Subject: Duke Energy Corporation  
Oconee Nuclear Station - Units 1, 2, and 3  
Docket Nos. 50-269, 50-270, and 50-287

Revisions to Topical Report DPC-NE-3003 In Support of  
Steam Generator Replacement  
Response to NRC Staff Request for Additional  
Information

Enclosed herein, please find the Duke Energy Corporation (Duke) response to the May 12, 2003 NRC staff's request for additional information concerning topical report DPC-NE-3003, Revision 1, "Mass and Energy Release and Containment Response Methodology."

### **Duke Power Response To Request For Additional Information**

**GOTHIC 7.0 - FATHOMS COMPARISON**  
**ROTSG STEAM LINE BREAK**  
**(0.6 ft<sup>2</sup> Break)**

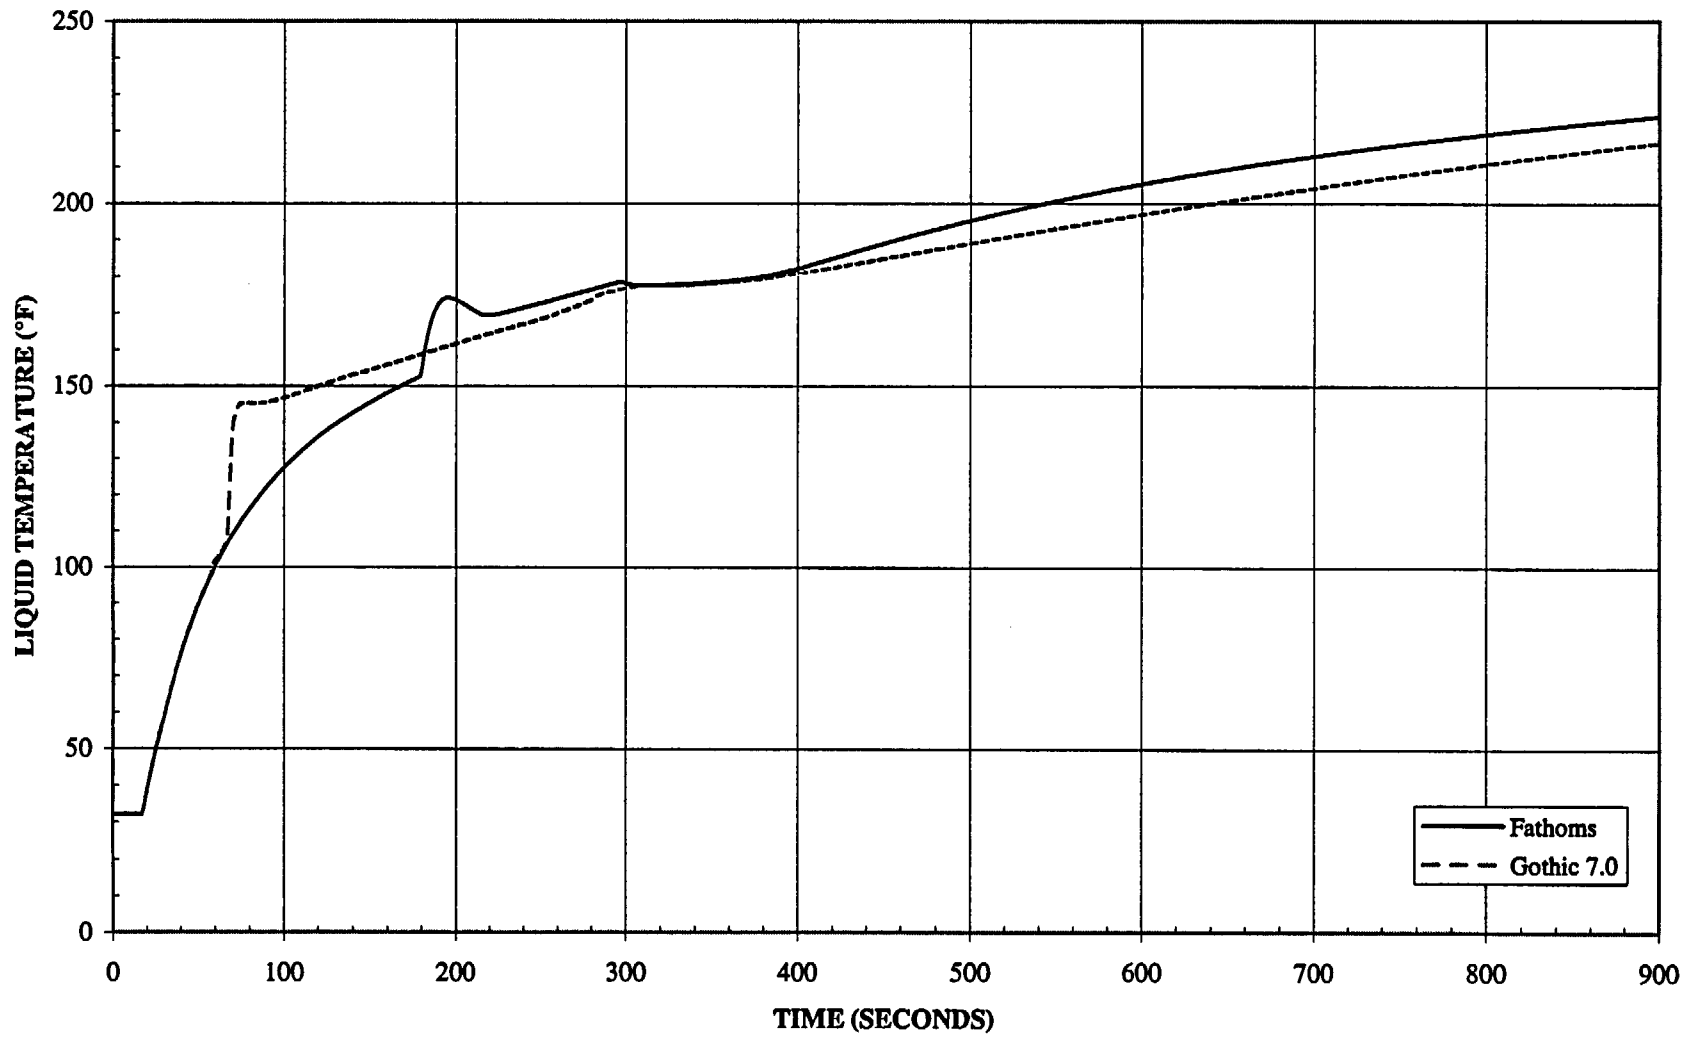
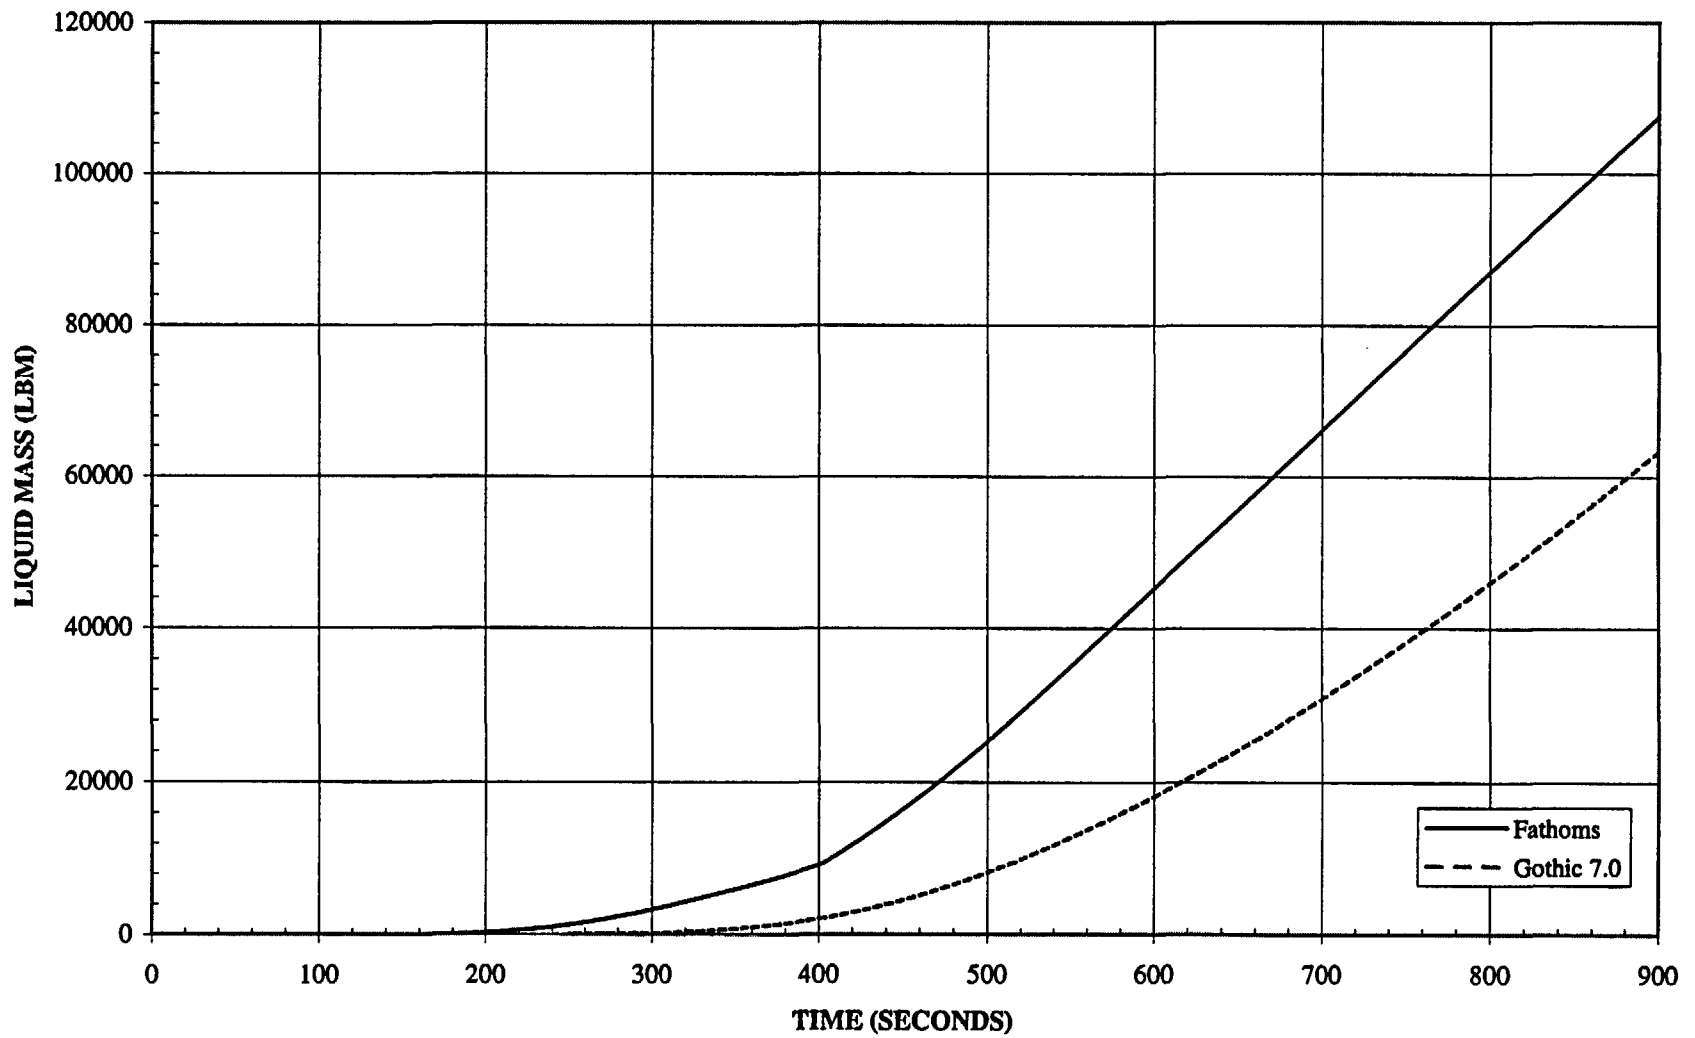
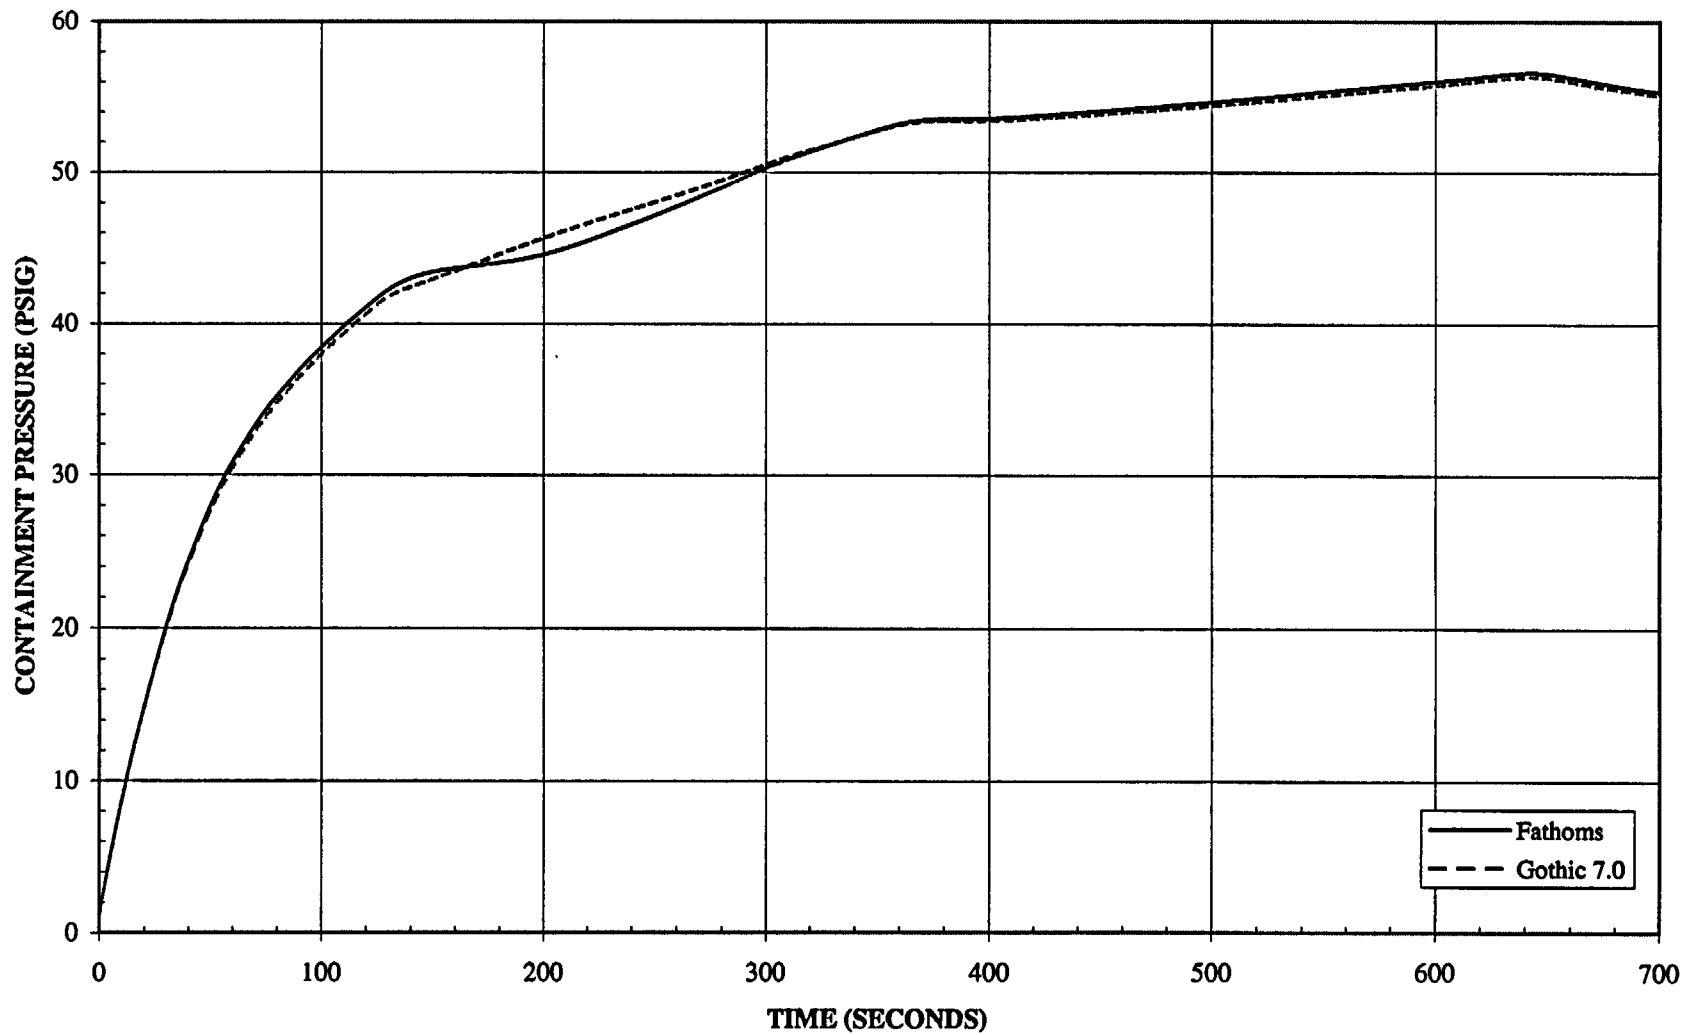
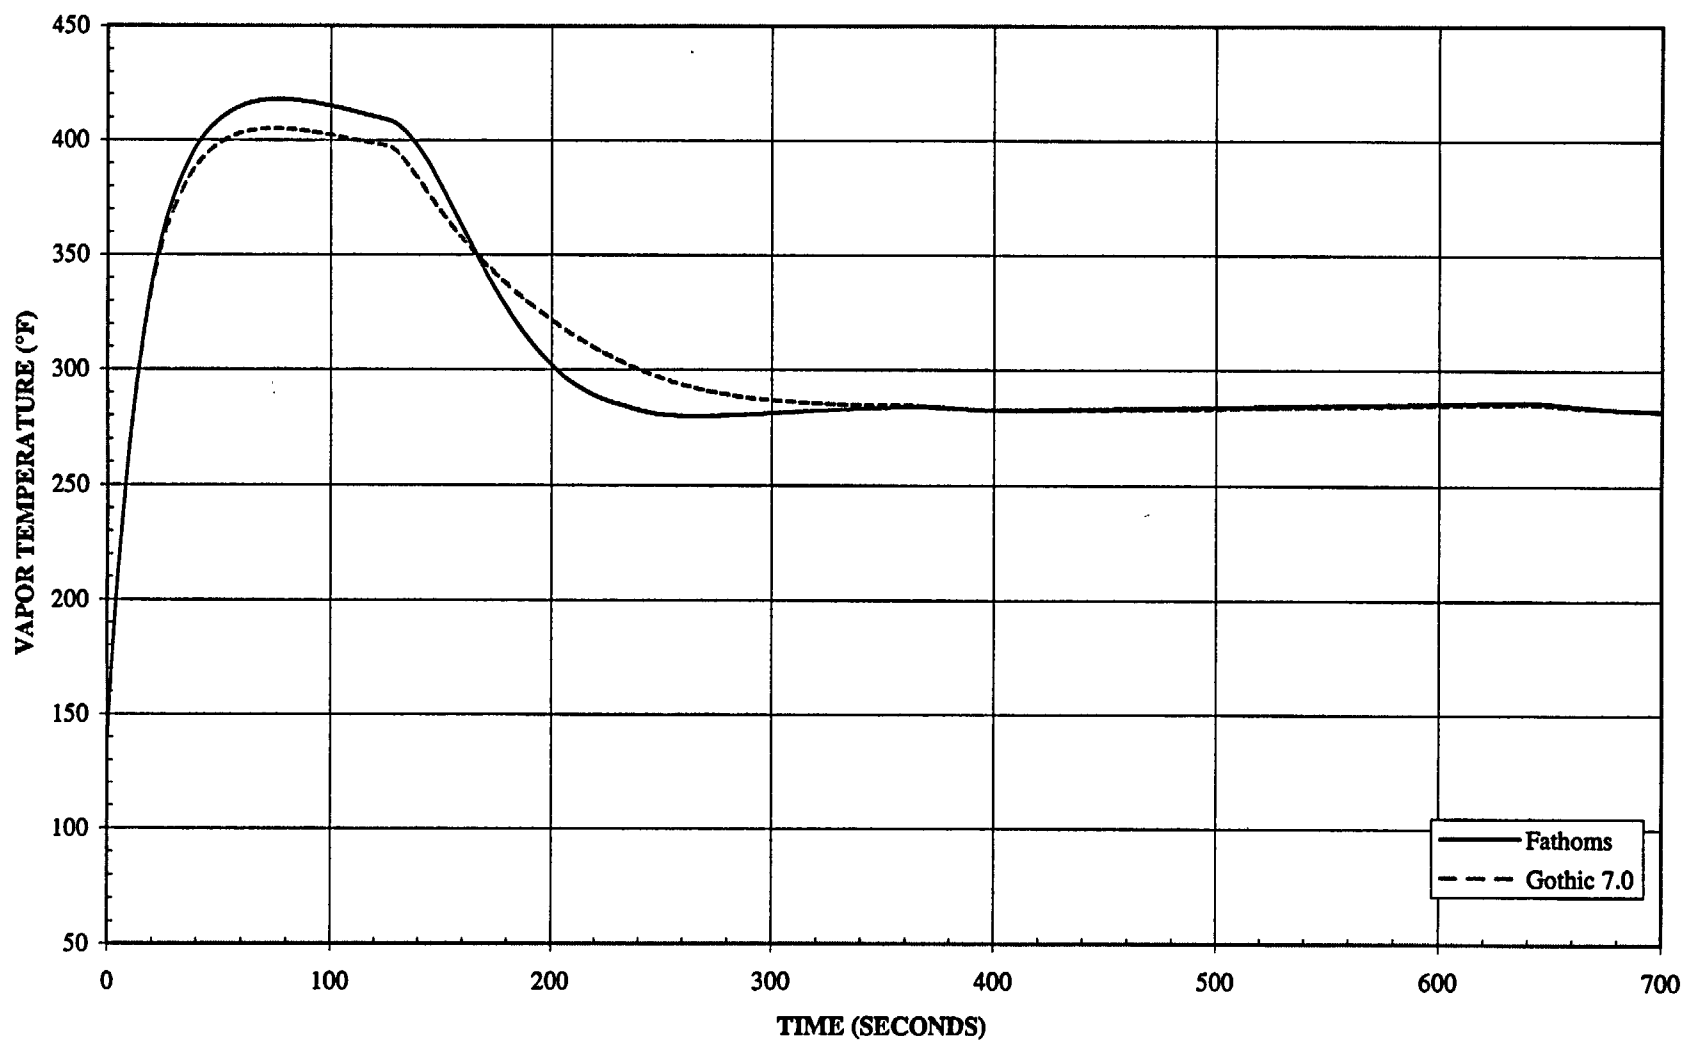
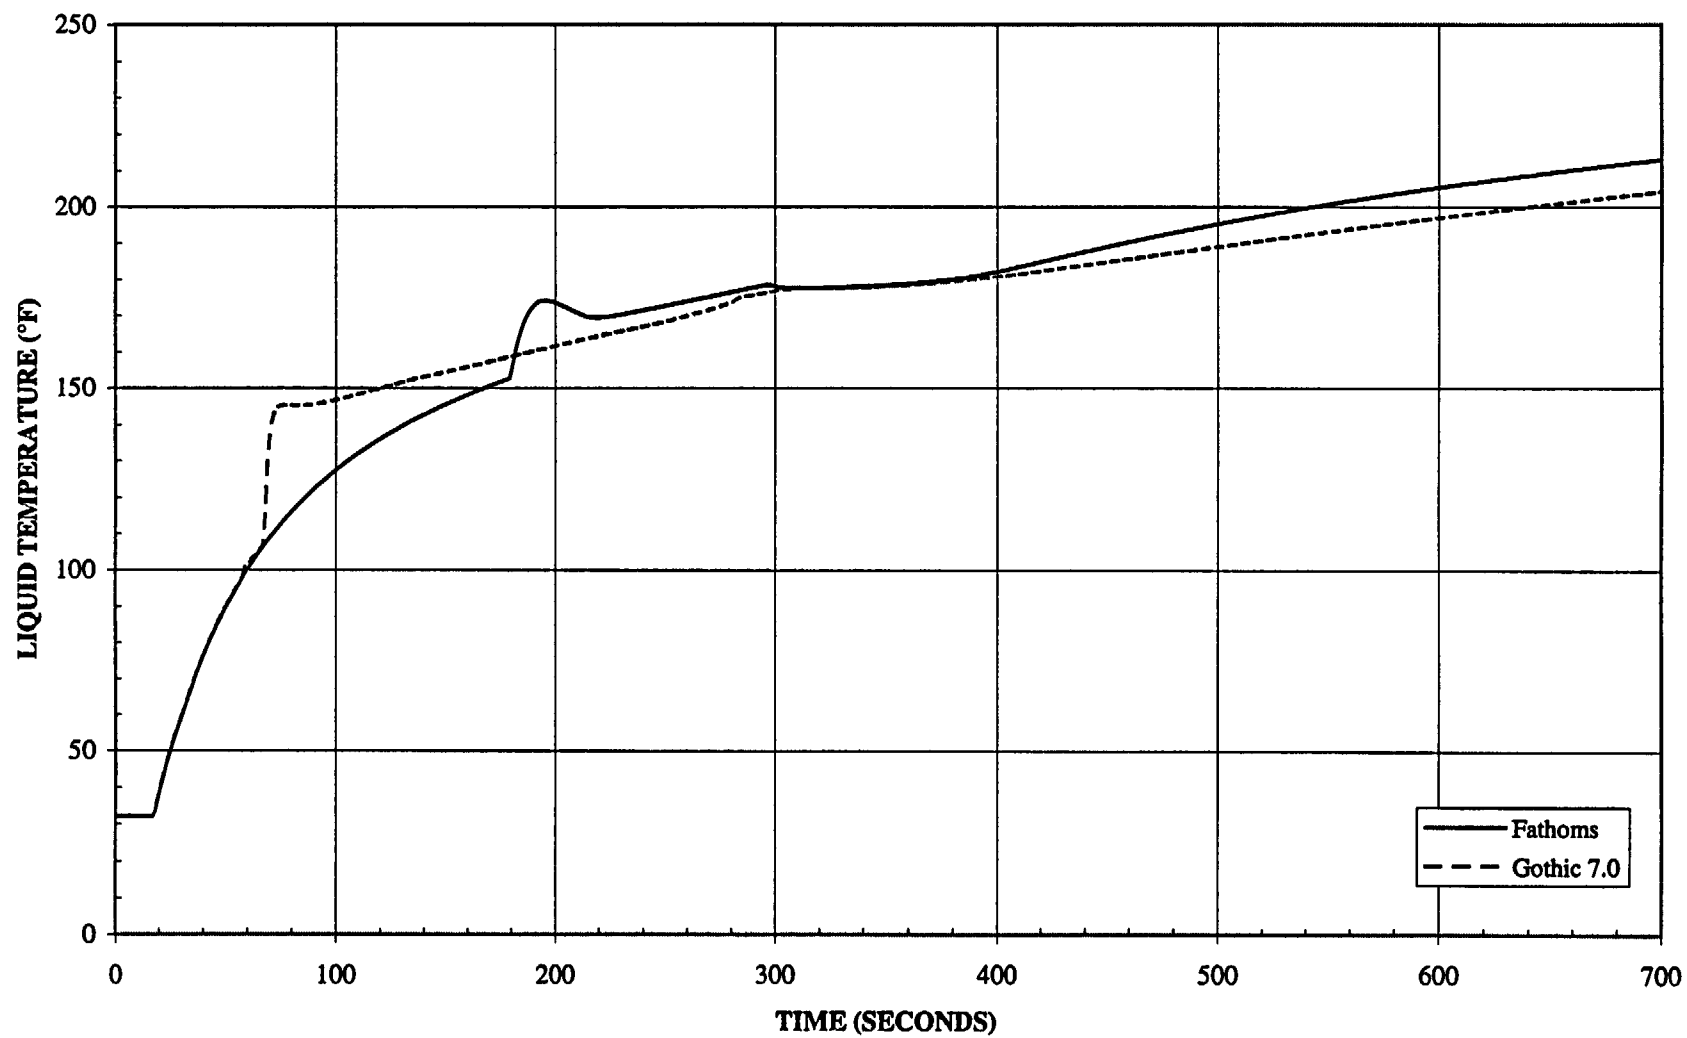
14. Show that GOTHIC and FATHOMS calculations result in the same pressures, temperatures, sump temperatures, etc. for the design basis LOCA and main steam line break events. If they do not, explain differences in terms of the differences in models between the two codes. (See Question 1.)

Response: Refer to the response to Question #3 for LOCA. The results of the 6 code comparison analyses for the main steam line break are given in Table 14-1 and the figures that follow. The containment response following a main steam line break event for the ROTSG was performed to compare the results from FATHOMS 2.4 and GOTHIC 7.0. In general, the pressure and vapor temperature responses are very similar. GOTHIC 7.0 predictions for peak pressures are slightly lower on the smaller break sizes (~0.3 psi) and slightly higher for larger break sizes (~0.95 psi). The peak vapor temperature responses predicted by GOTHIC 7.0 overall are slightly lower (~12°F). For larger break sizes, the higher pressure predicted by GOTHIC 7.0 may be attributed to additional steam generation from the improved interface heat and mass transfer models and from the drops that are generated due to dripping. The slightly lower pressure for smaller break sizes may be attributed to additional droplets in the atmosphere. The slightly lower vapor temperature and liquid temperature in GOTHIC 7.0 for all break sizes may be attributed to additional droplets in the atmosphere also. This effectively increases the heat capacity of the atmosphere and reduces the temperature rise for a given energy addition. As discussed in the responses to Questions #1 and #3, more liquid is predicted to remain in droplet form in GOTHIC 7.0 which results in less liquid mass in the sump. In addition, the lower sump temperature predicted by GOTHIC 7.0 may be attributed to the addition of the second energy equation for the drops and the improved heat and mass transfer models in GOTHIC 7.0.
